Recall Code 0828 - Horn Wire Routing for 2004 XB9S, XB9SL and XB12S

Buell Motorcycle Company has determined that a condition, relating to motorcycle safety, exists involving 2004 model year motorcycles built between June 23, 2003 and August 27, 2003. This condition involves the wire that provides power to the horn, which due to mis-routing, can become frayed from contact with the horn bracket mounting bolt. The result is that the horn wire becomes exposed, and when the horn button is pushed, either the horn circuit fuse or the key switch fuse can blow. If the horn fuse blows, the horn and rear brake light will no longer function. If the key switch fuse blows, in addition to the horn and rear brake light not functioning, the vehicle can lose ignition and create a "quit while riding" situation. A "quit while riding" situation could result in an accident.

Figure 1-1. Horn Assembly Behind Windscreen

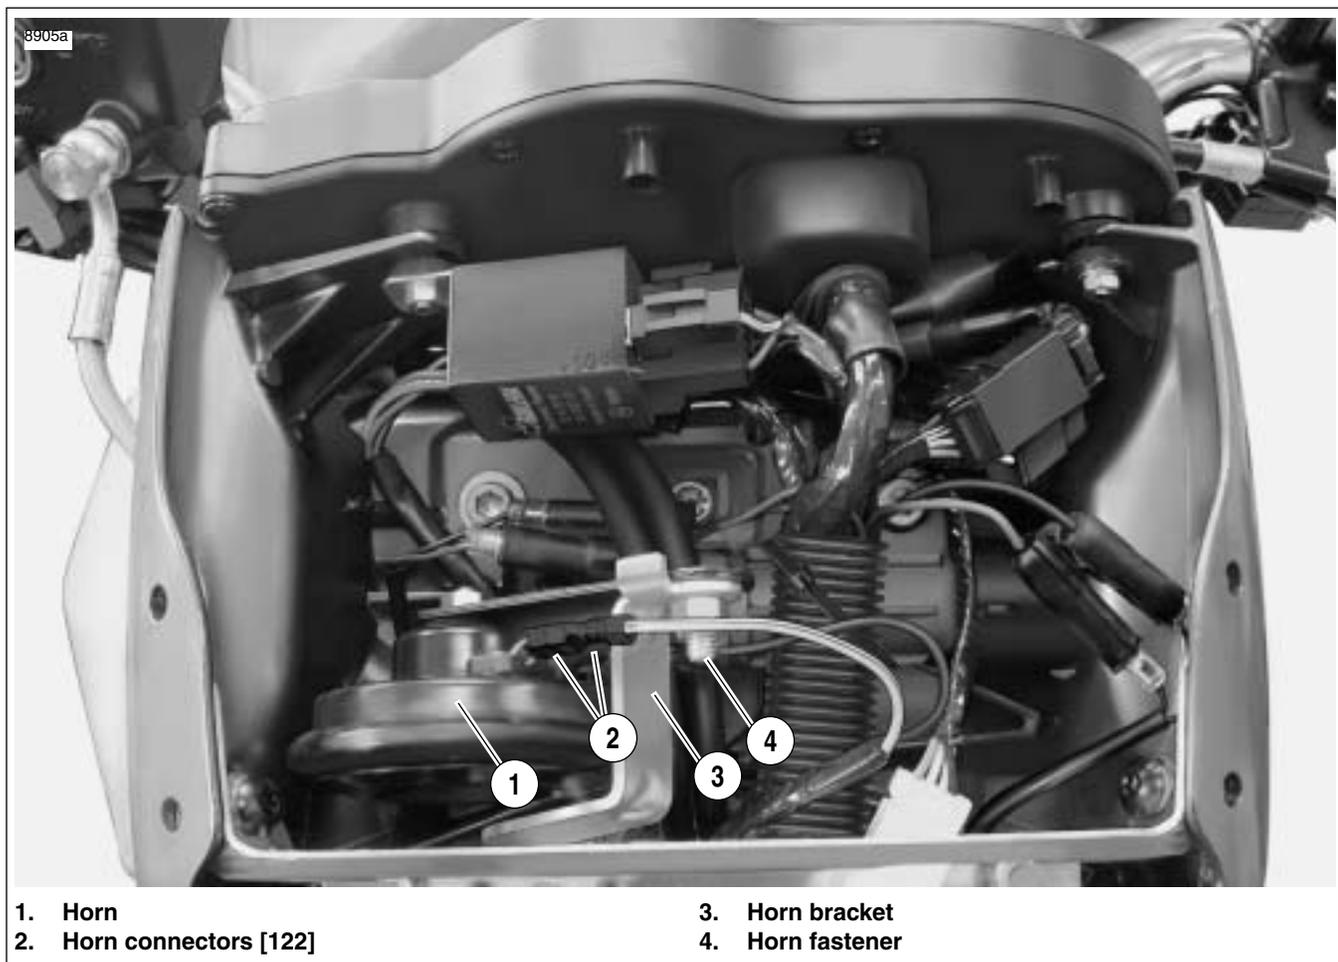
2. Disconnect battery by unthreading fastener and removing negative cable (black) from battery first.
3. Remove windscreen.
4. See Figure 1-1. Disconnect horn connectors [122] (2) and remove horn fastener (4) and horn (1).

5. Install horn (1) using new fastener from kit and tighten fastener (4) to 72-96 in-lbs (8.1-10.8 Nm).
6. Inspect horn wire for damage. If damaged, see WIRE REPAIR SECTION next page.
7. Connect horn connectors [122] (2).

8. Inspect horn wire routing to ensure there is no contact. Correct as necessary.
9. Install windscreen and tighten fasteners to 10-12 in-lbs (1.1-1.4 Nm).
